TITLE OF JOB
 B-5
 BRACKNELL GDNS
 LONDON N.W.3

TITLE OF SHEET
 GROUND & FIRST
 FLOOR PLAN

DRAWING NUMBER
 980 / 150 (R)

TITLE OF SHEET
 ROOF PLAN &
 SECTION A-A & B-B

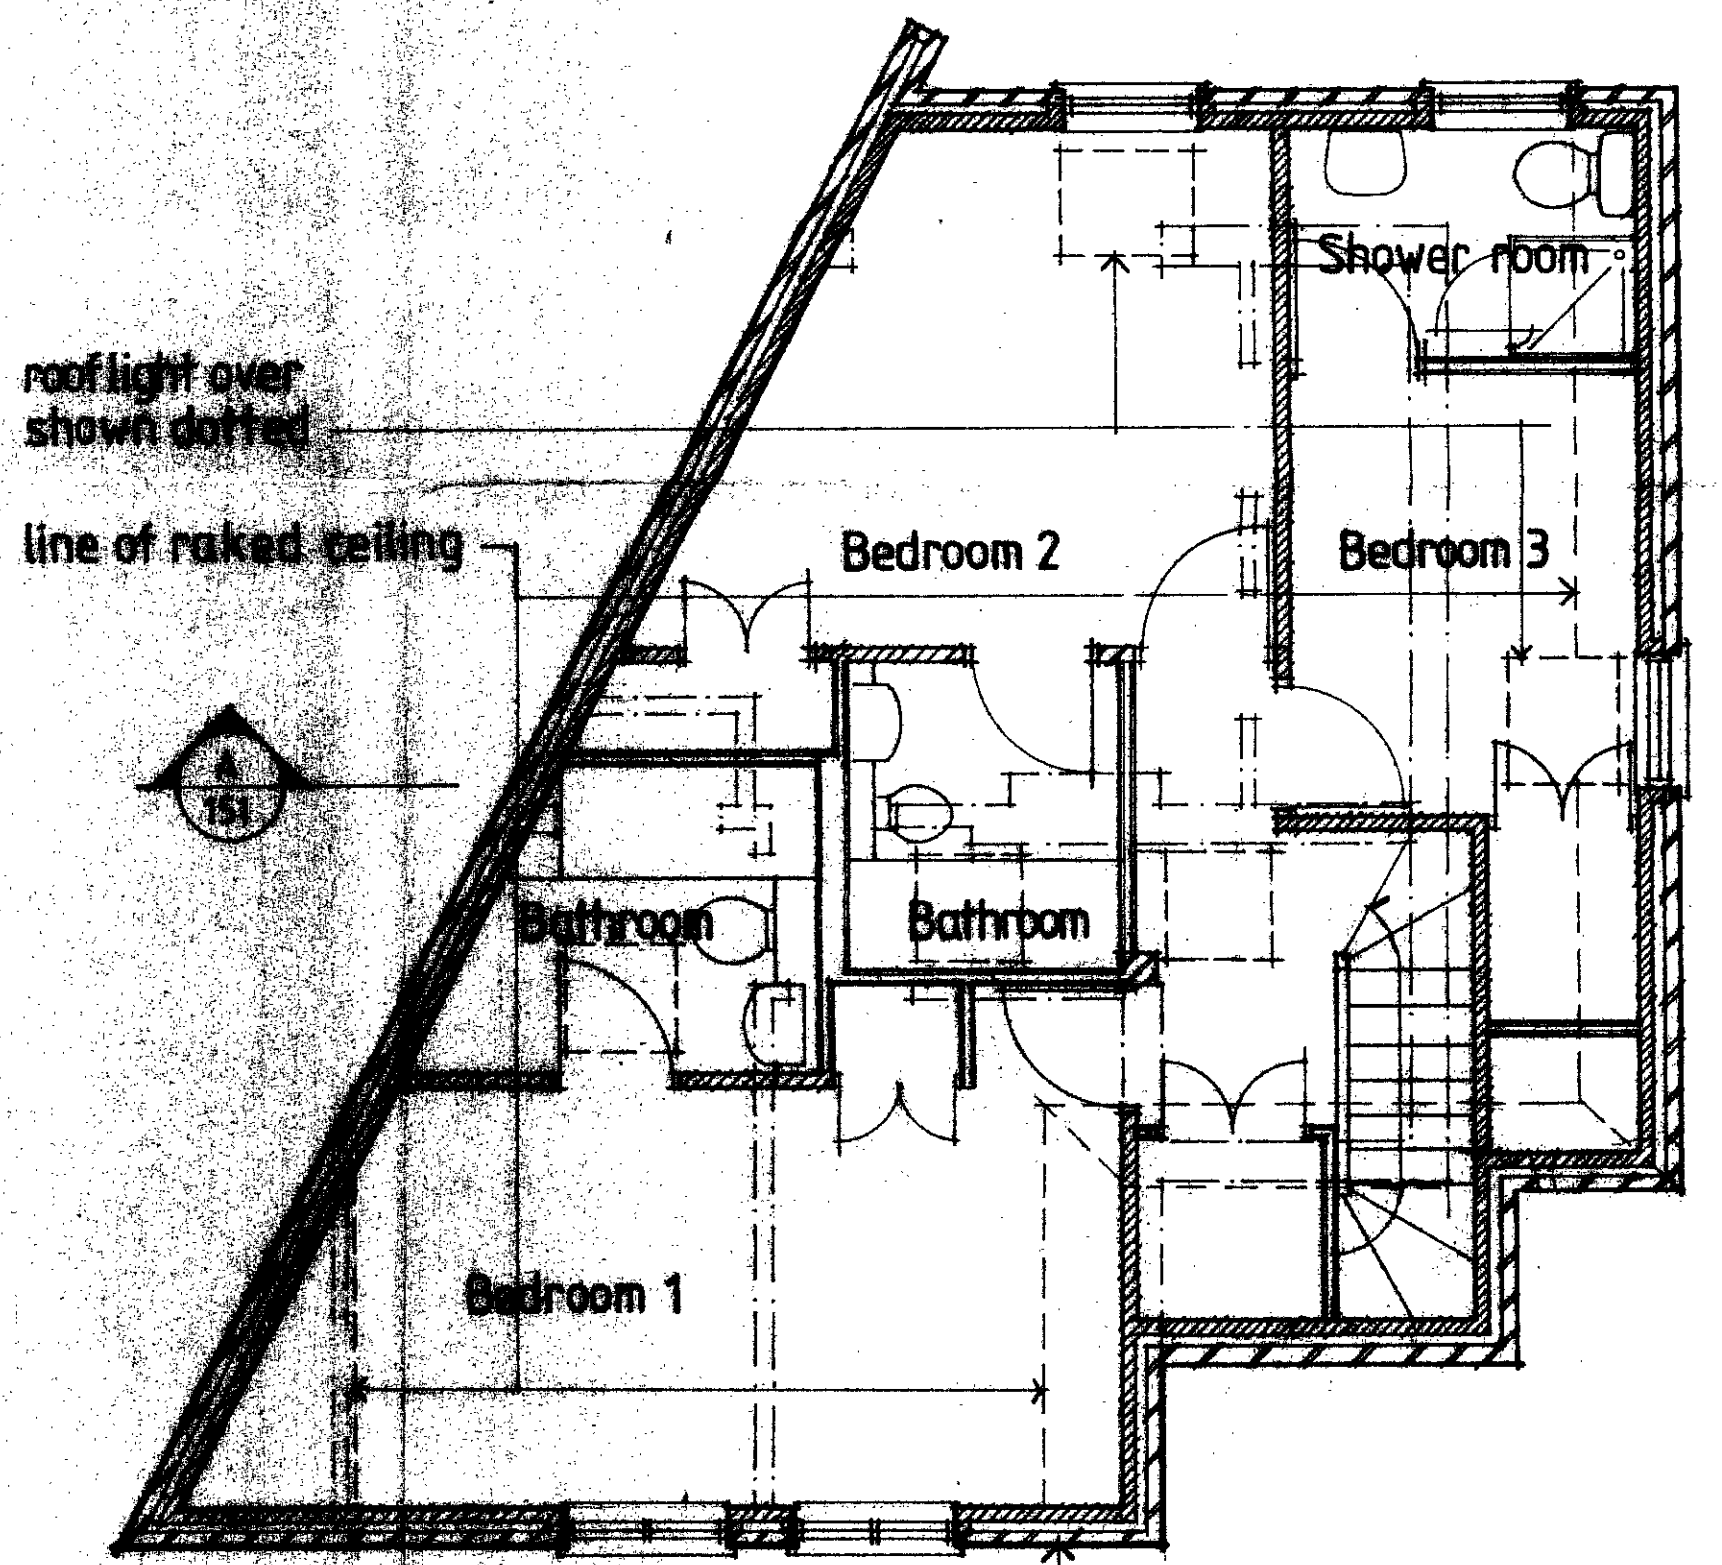
REVISIONS	DATE
(R) EXTENT OF NEW CONSTRUCTION REVISED TO REFLECT ADDITIONAL TAKING DOWN ALREADY COMPLETED TO SAFE GUARD STRUCTURAL STABILITY.	4-93

existing flank wall taken down to sound structure and rebuilt on existing line in new cavity construction

DRAWING NUMBER
 980/ 151 (R)

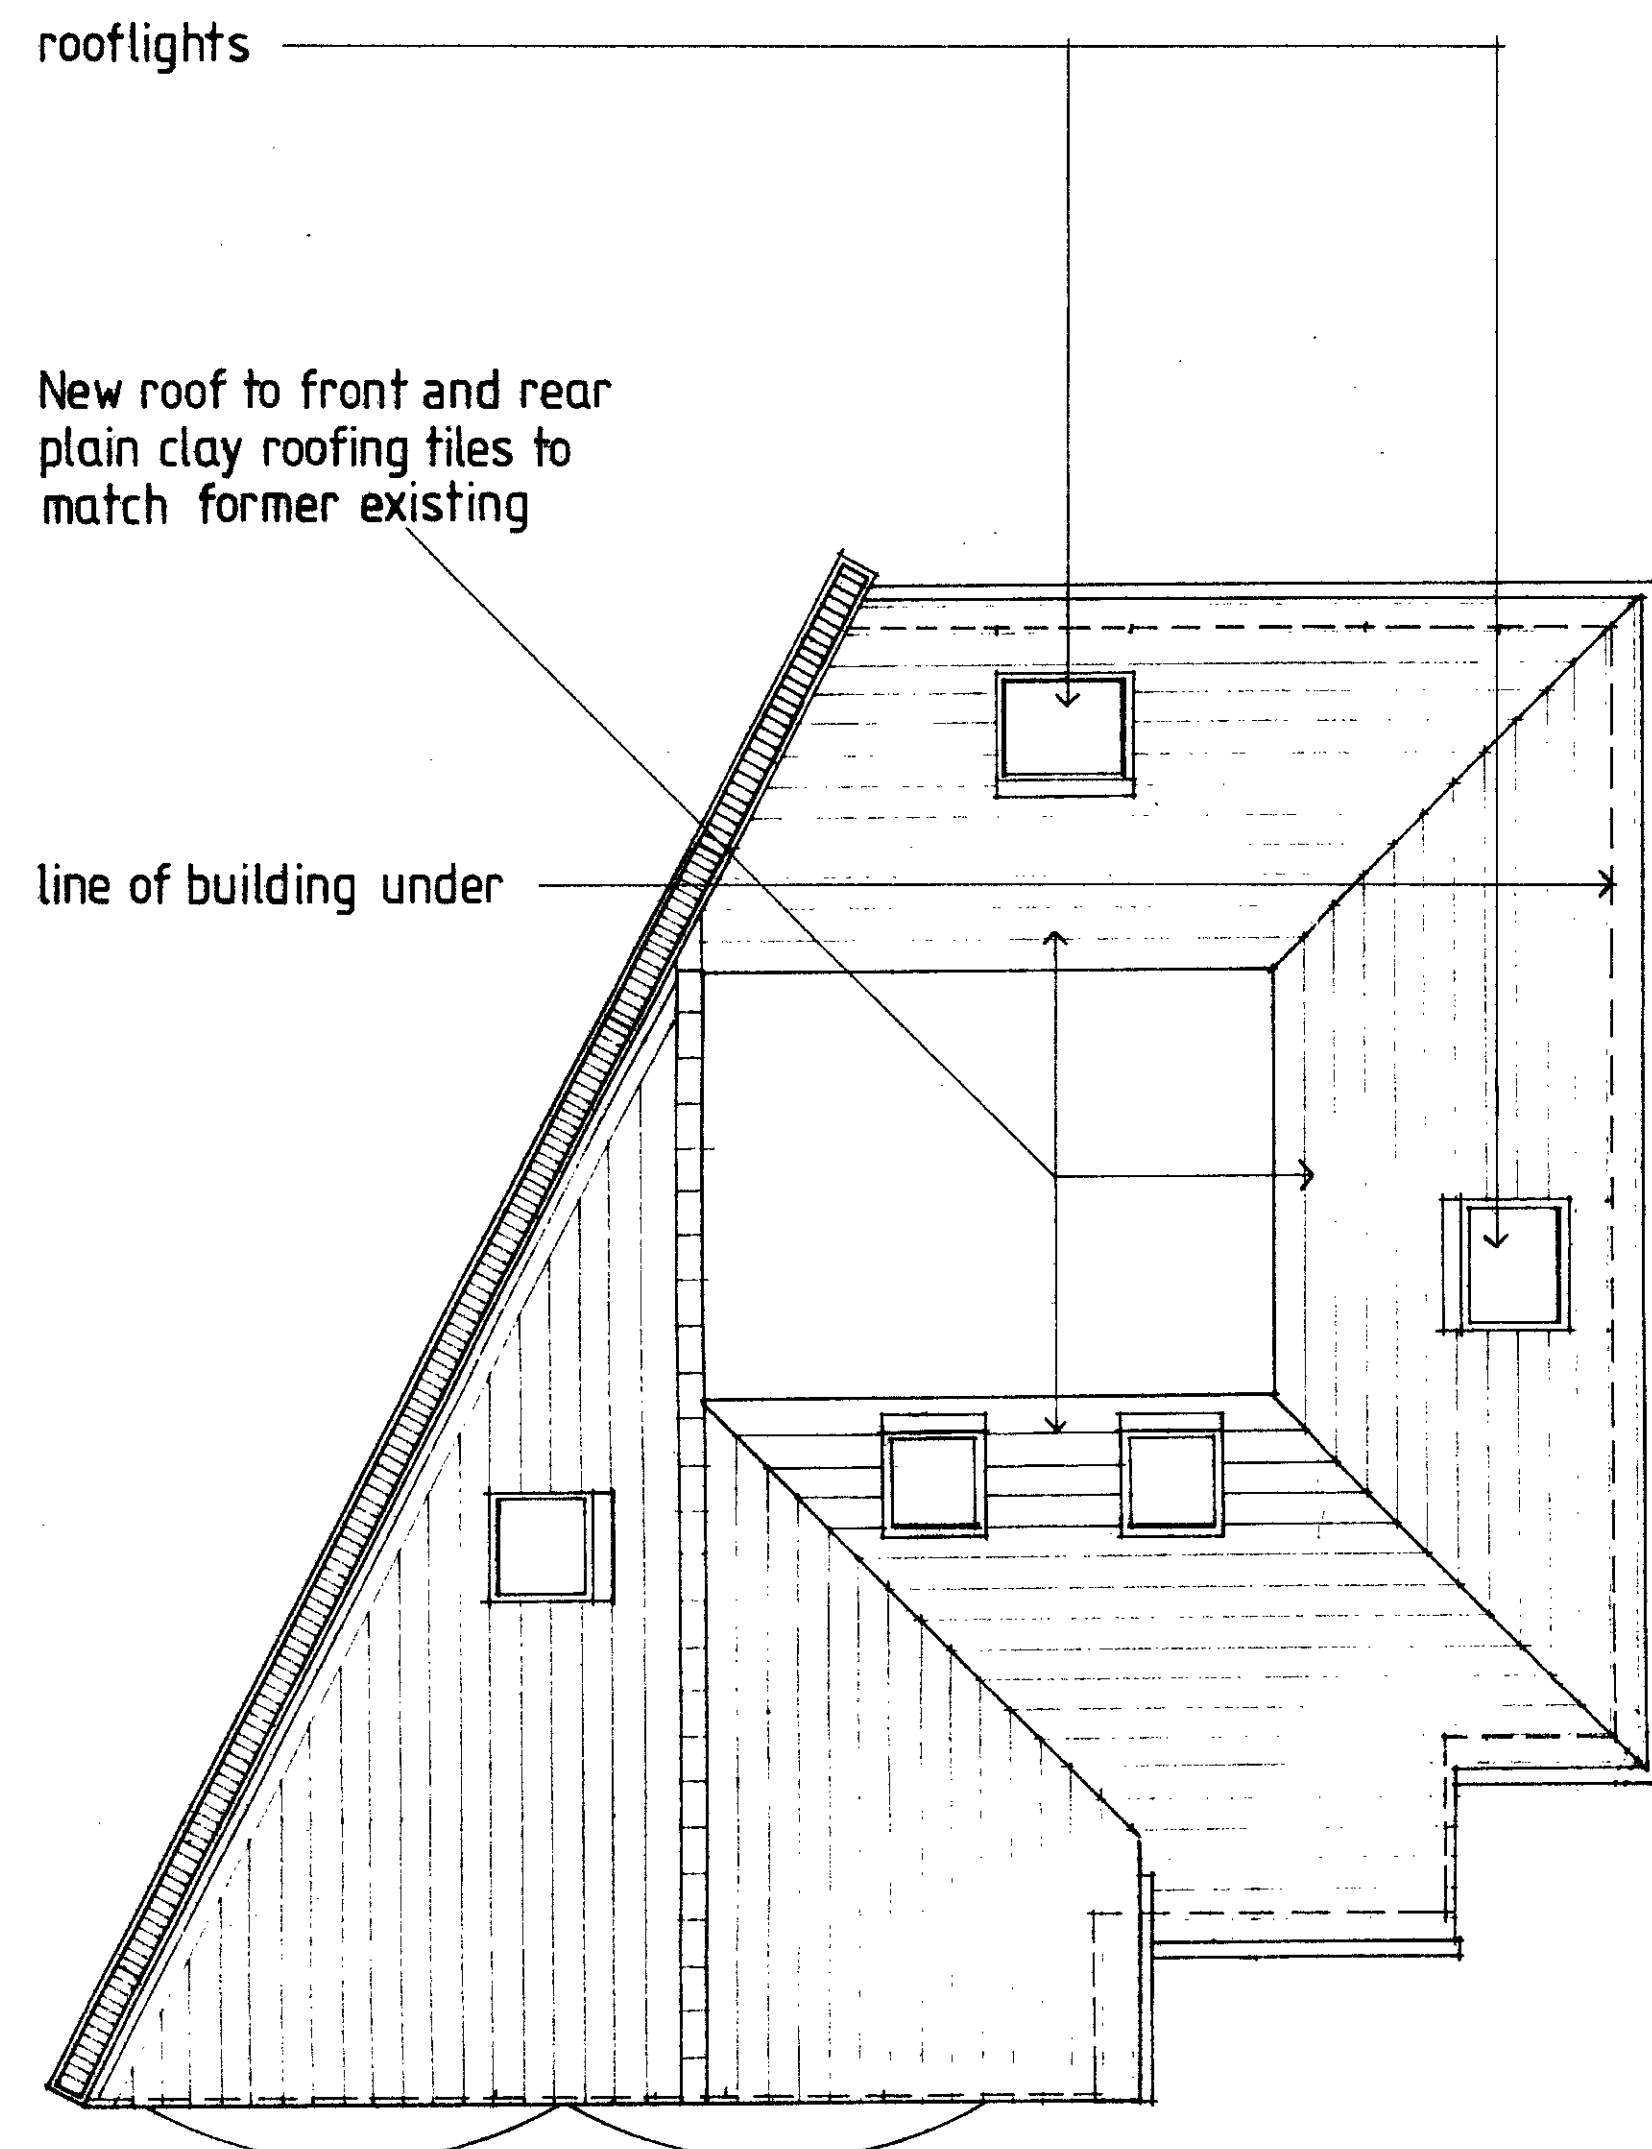
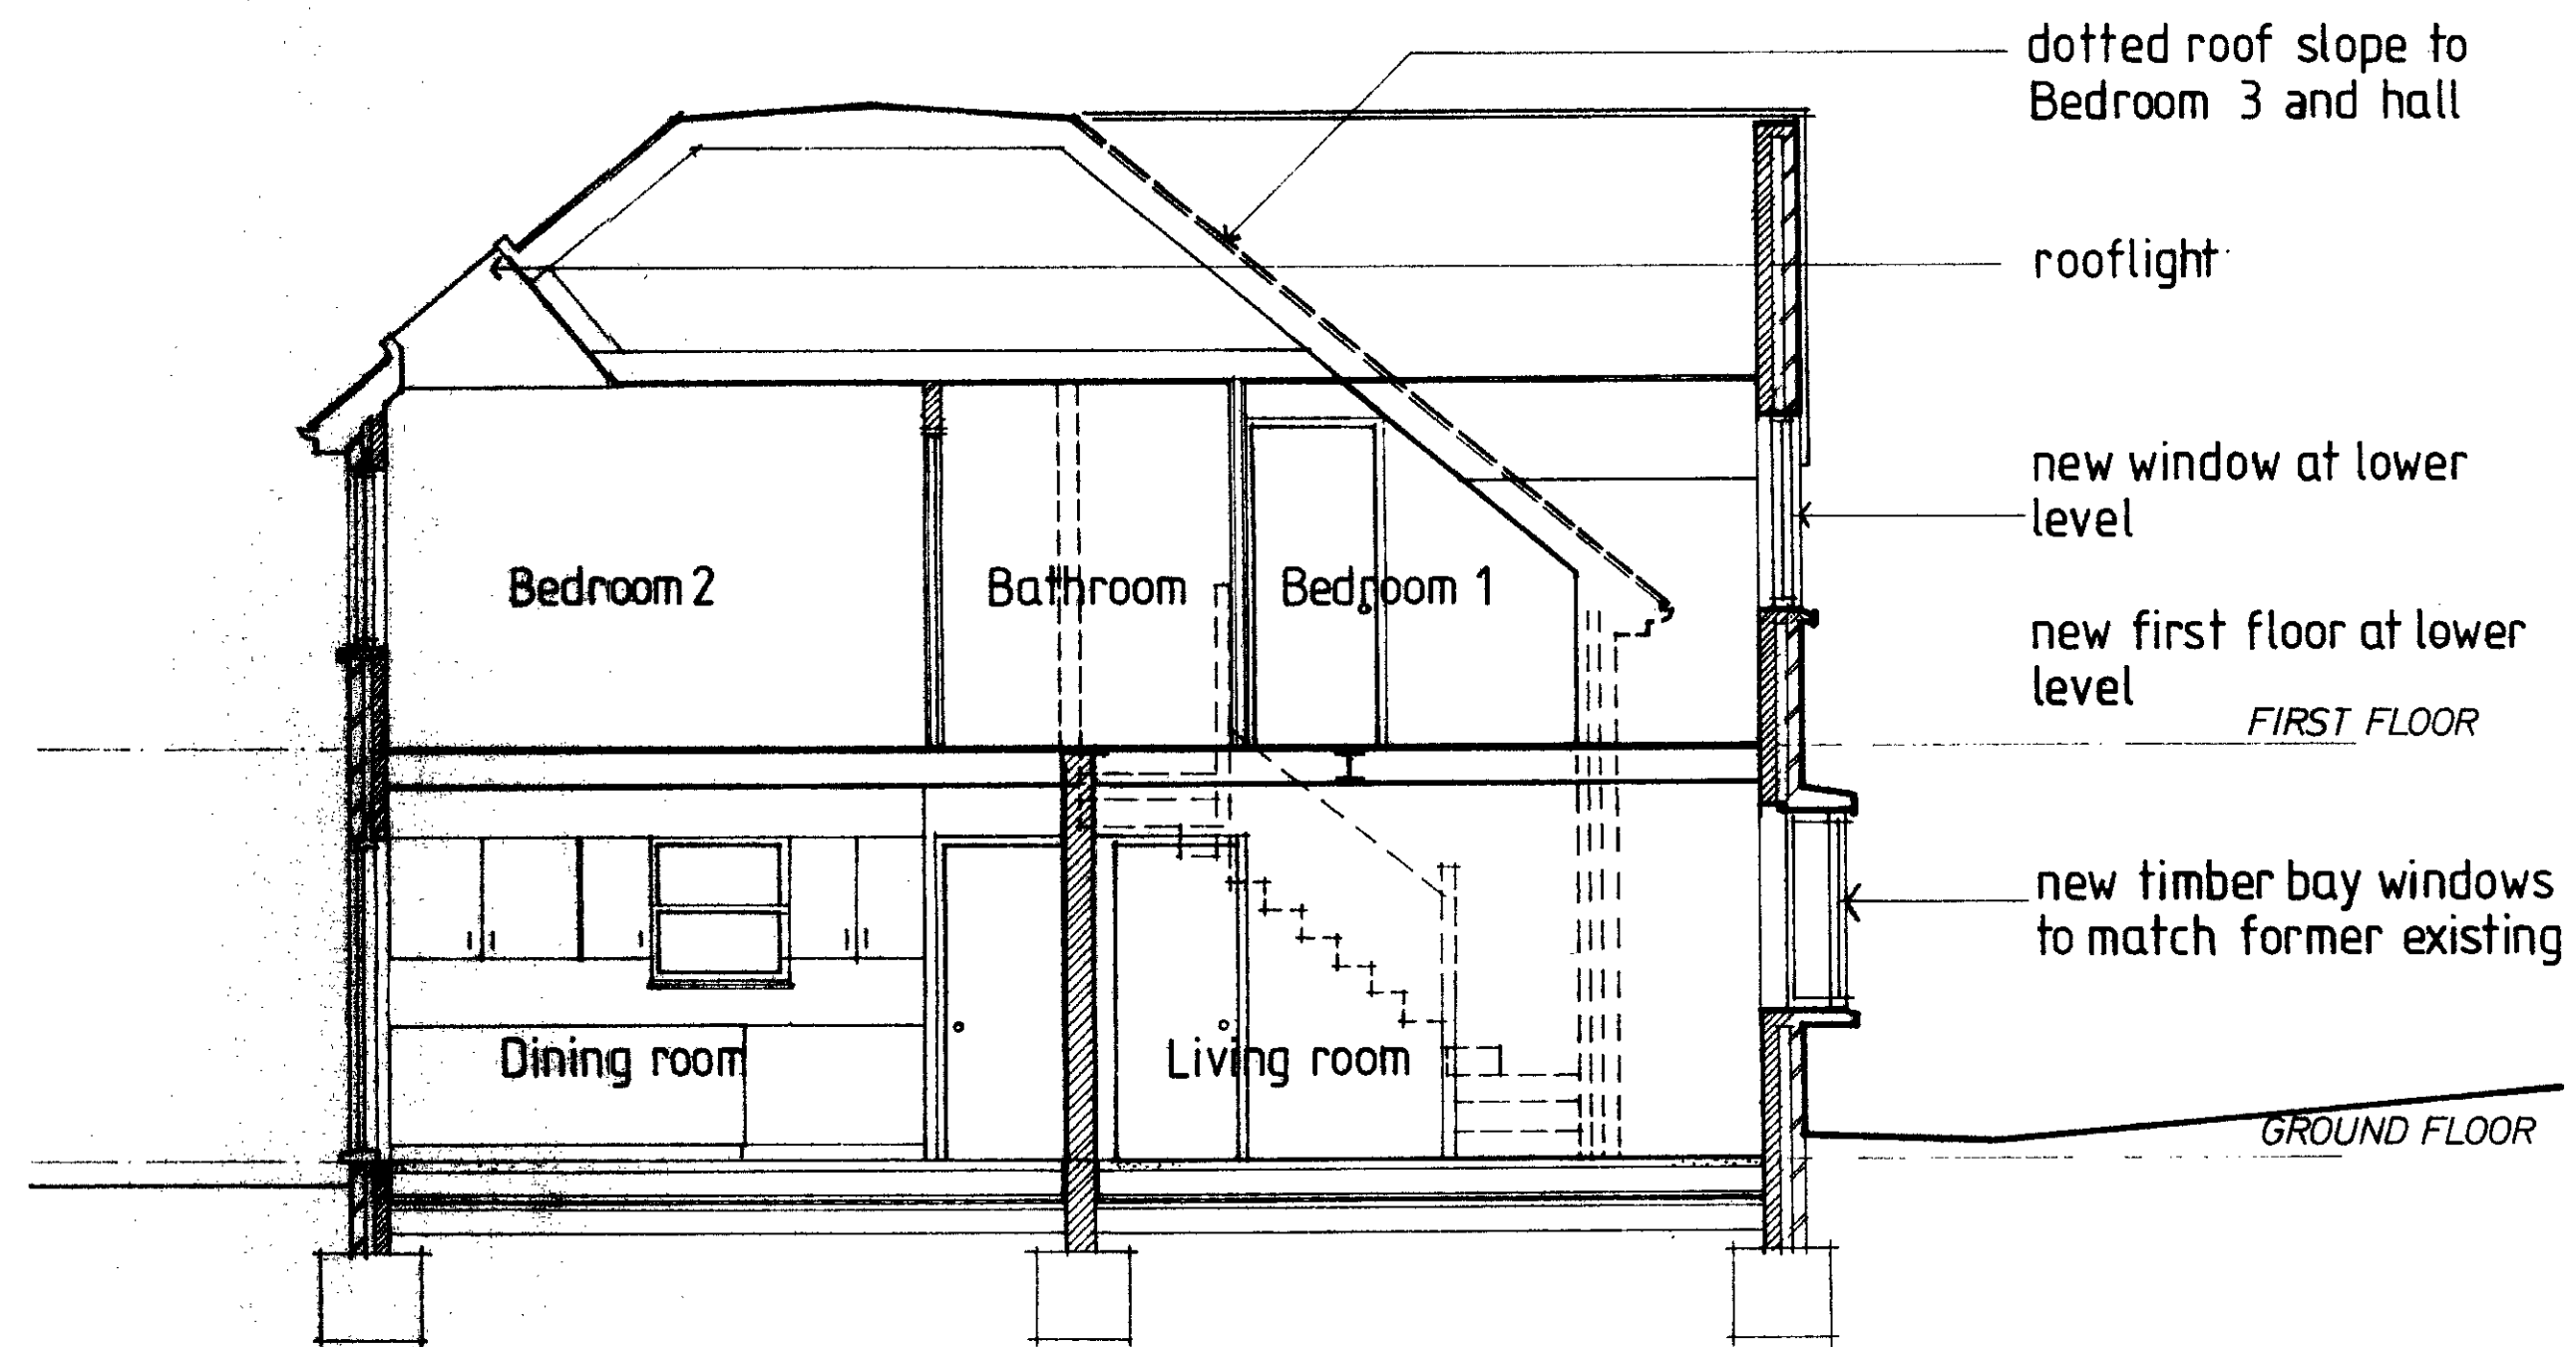
REVISIONS	DATE
(R) EXTENT OF NEW CONSTRUCTION REVISED TO REFLECT ADDITIONAL TAKING DOWN ALREADY COMPLETED TO SAFE GUARD STRUCTURAL STABILITY.	4.93
